From: Ted and Kathy Frick  
1812 S. Weimer Rd.  
Bloomington, IN 47403  
Date: March 14, 2024  
To: Bloomington Plan Commission  
Re: Proposed Summit District PUD-18-23 along South Weimer Road

### **Summit District PUD Transportation Issues**

To: City of Bloomington Plan Commission  
From: Arbor Ridge Homeowners Association Board of Directors  
RE: Sudbury Partners LLC Rezoning Request  
Date: July 28, 2023

To: City of Bloomington Plan Commission  
From: Arbor Ridge Homeowners Association Board of Directors  
RE: Comments on Plan Commission Hearing of PUD-18-23 Sudbury Development Partners LLC, Sept. 11, 2023  
Date: August 22, 2023

Figure 1. Summit District PUD nearby streets. Red circles are anticipated choke points.

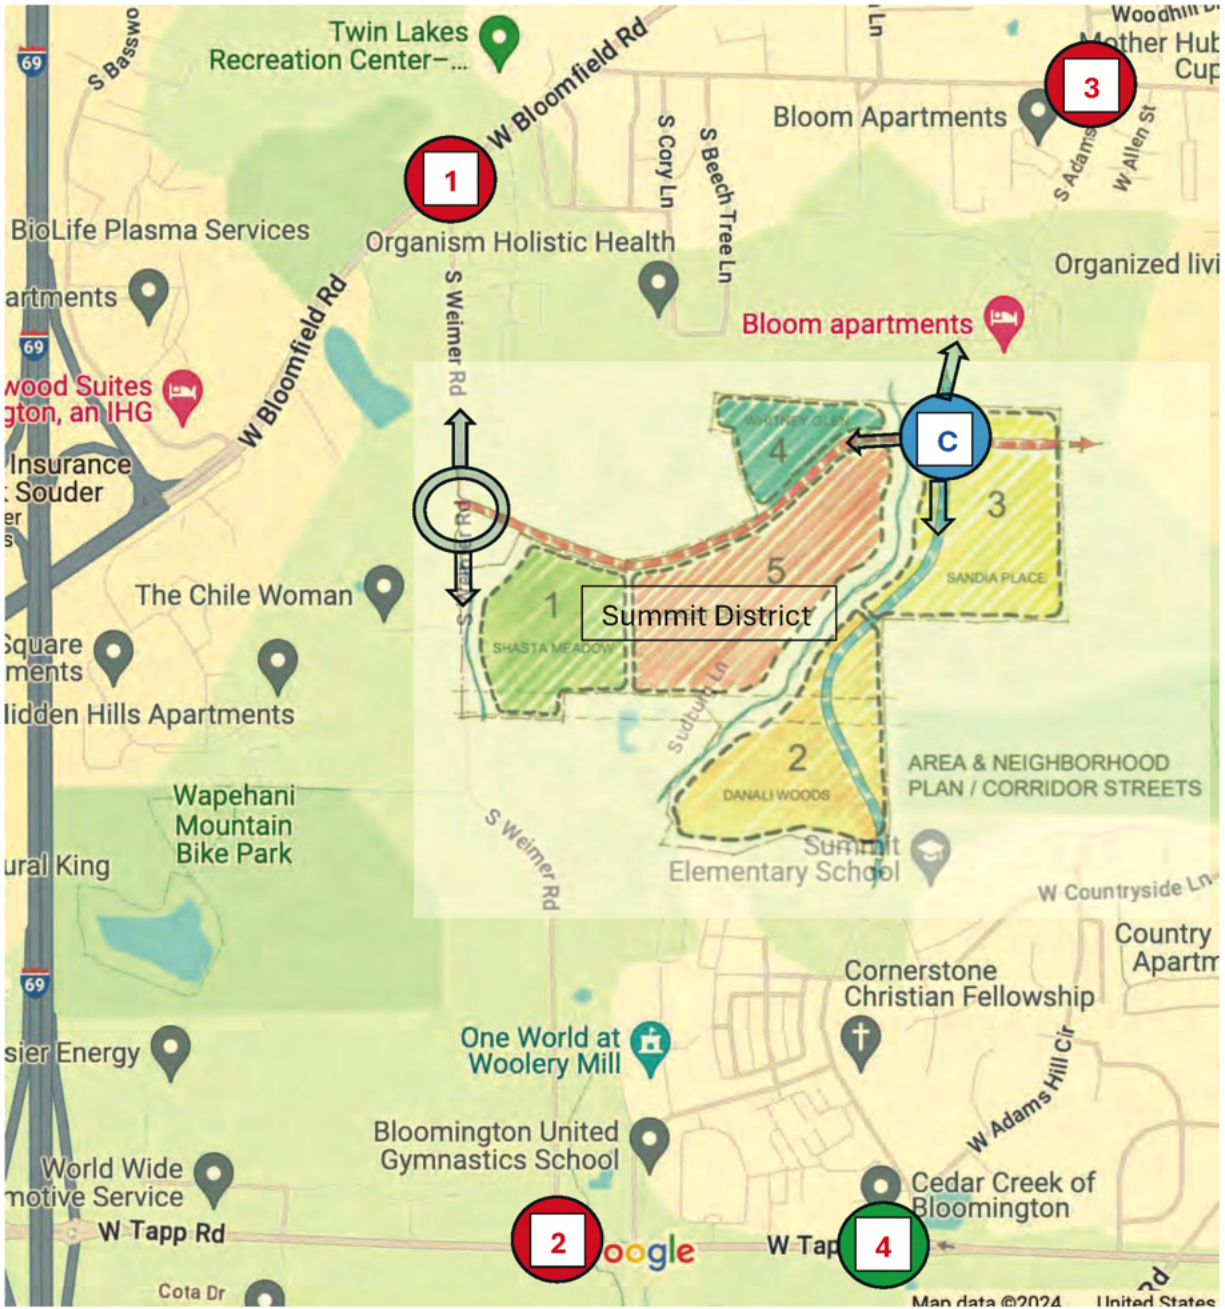
The Summit District PUD is likely to create increased traffic congestion at 3 main choke points for outbound automobile traffic, especially during rush hours:

1. Weimer Rd. stop sign at Bloomfield Rd. Bloomfield Rd. traffic does not stop.
2. Weimer Rd. stop sign at Tapp Rd. Tapp Rd. traffic does not stop.
3. Adams St. at Allen St. Currently a 4-way stop.

See red circles 1, 2, and 3 in Fig. 1 below. The proposed Summit District PUD-18-23 would heavily impact traffic on Weimer Rd, as explained below, especially if many of the new people in the Summit District try to exit to the west via Sudbury Dr. and turn onto Weimer Rd. to get to Tapp Rd. or to W. 2<sup>nd</sup> St. (Bloomfield Rd.). The intersection of S. Adams St. and Tapp Rd. is now a roundabout, and unlikely to be a choke point (green circle 4 in Fig. 1).

The current infrastructure of roads and streets surrounding the proposed Summit District PUD will be inadequate to handle significantly increased automobile traffic. We anticipate significant congestion at the 3 choke points (red circles in Fig. 1).

1. Build a roundabout or add a stoplight at each end of Weimer Rd. Widen narrow bridge on south end of Weimer Rd. *or* build new section of S. Weimer Rd. from Wapehani Rd. to Tapp Rd., so as to avoid the current S-curve and narrow bridge. The closed portion of southern old Weimer could then become an extension of the Clear Creek Trail.
2. Make Sudbury Dr. a through route from Weimer Rd. to S. Rogers St. with a stoplight or a roundabout at Sudbury and Rogers.
3. Change intersection of S. Adams St. and Allen St. to a two-way stop on Allen, with Adams not stopping; or build a roundabout at the intersection.
4. Decrease overall density of the Summit District PUD by a significant amount, so that much less traffic would be going from and coming to the Summit District.

*Figure 1.* View of "Shasta Meadow" Hillside from 1812 Weimer Road. Photo by T. Frick, 9/03/2023. Possible location of proposed Weimer Retention Pond and text annotations are superimposed (also see Figure 2). Clear Creek is not visible here because of the steep slopes along the riparian buffer.

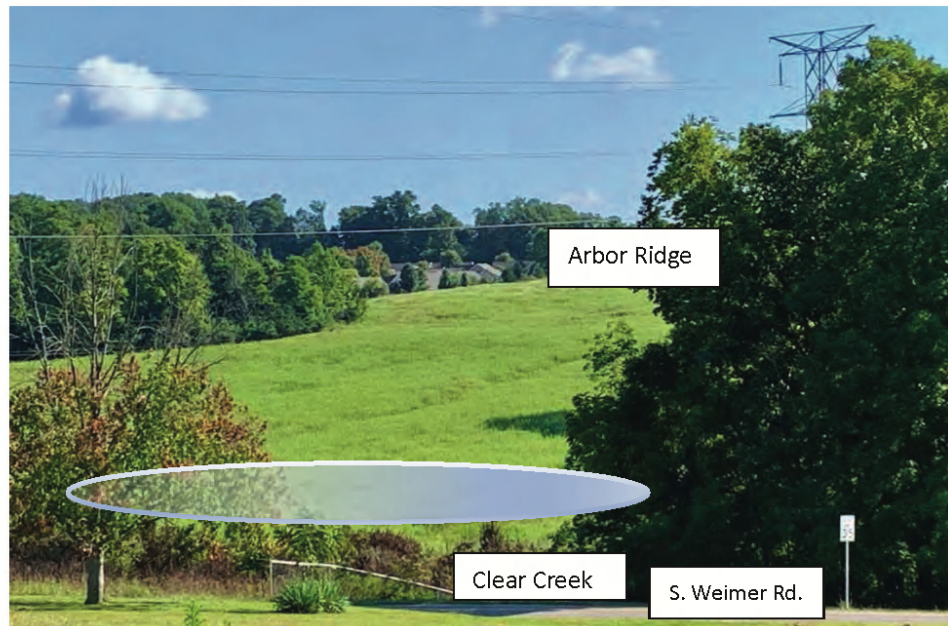
We have been looking out the windows of our house to the northeast at the increased erosion on the steep hillside for 5 decades. This hillside is now referred to as Shasta Meadow (Neighborhood #1) in the Summit District PUD proposal documentation from Plan Commission

Figure 2. Proposed Weimer Retention Pond on Shasta Hillside<sup>1</sup>

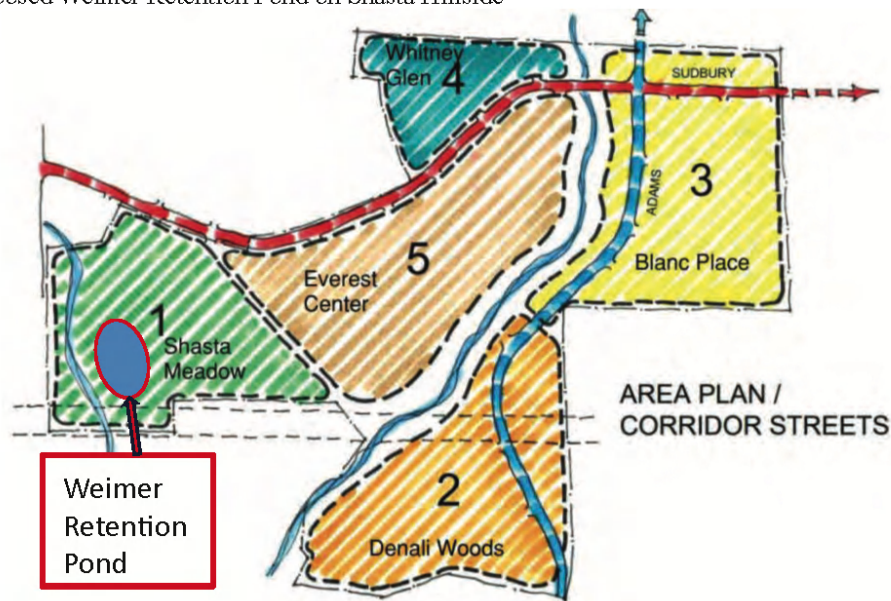
One way to do this would be to build a storm-water retention pond along the bottom of the western hillside but above Clear Creek as part of the proposed Summit District PUD. Engineers would be able to figure out how big the pond should be, given the severe slope and the increased run-off from impermeable surfaces to be added in the development.

If designed carefully, the retention pond should *decrease* the amount of flooding along the Weimer-Road-Clear-Creek flood plain. If the Summit District PUD does provide this retention pond, it could actually reduce the overall flooding that currently occurs after heavy rainstorms. Instead of making the flooding problem worse, it could help decrease the flooding along Clear Creek and Weimer Road after heavy rains.

**FIGURE 1. Map of sensitive soils in Bloomington and surrounding areas**

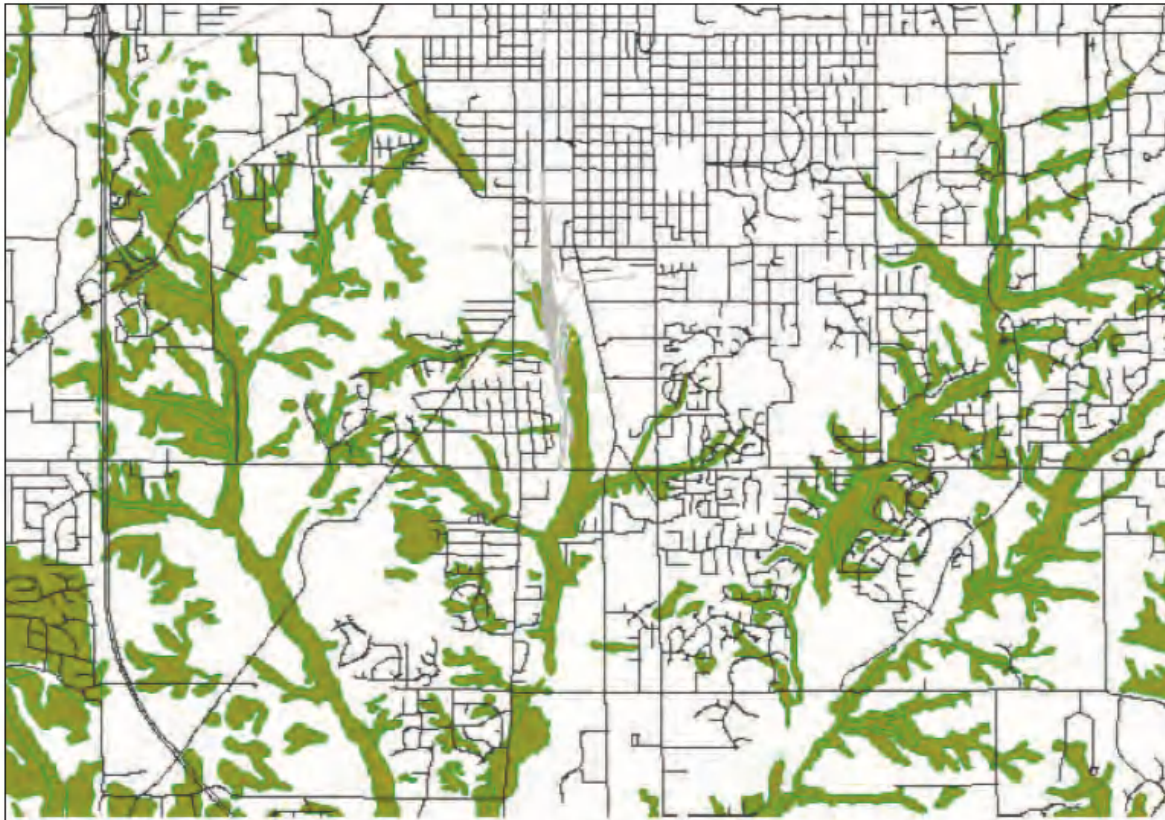
Has the Petitioner considered the sensitive soils present in this area in its planning? Given the age of the COBERI report, so much population growth, urban development and has occurred, and much green space has been lost since 2003. Have the sensitive soils areas grown since 2003? Have they become more prone to mass wasting process (erosion)?

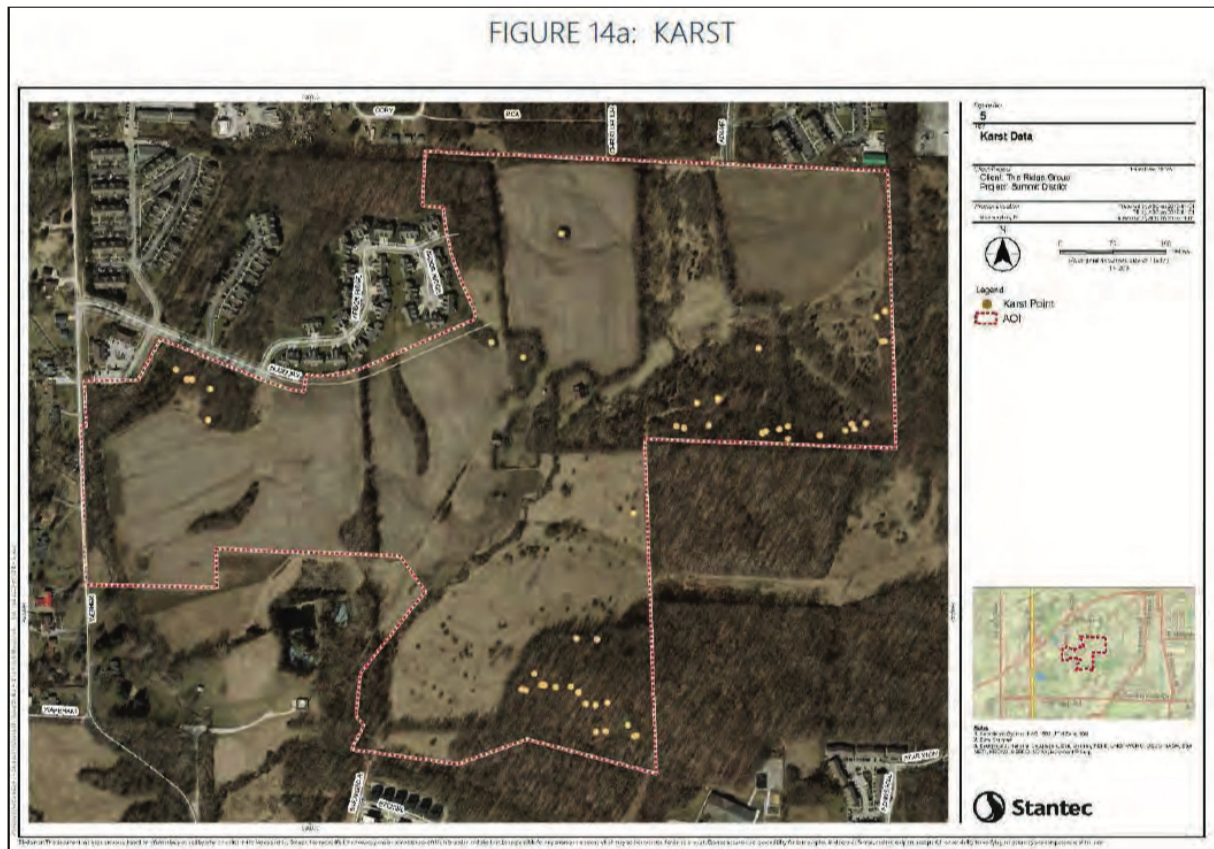
In regard to karst features, the Petitioner (Sudbury Development Partners, LLC) provided a map, “establishing specific environmental site features” (FIGURE 14a: KARST) in its Preliminary Plan. FIGURE 14a: KARST can be found on Page 159 of the meeting packet of the July 10 Plan Commission meeting. See screenshot below for the map provided by the Petitioner.

One can easily count approximately a total of 45 to 48 yellow dots (some adjacent to each other) representing karst features dotted all around the Summit District PUD, with several of them being in very close proximity to each other. It is unclear whether these karsts are surface, subterranean (surface) or compound. A quick search in the PDF did not produce any further explanation from the Petitioner. The Petitioner did not request exceptions on karst, so the Unified Development Ordinance (UDO) of the City of Bloomington applies.
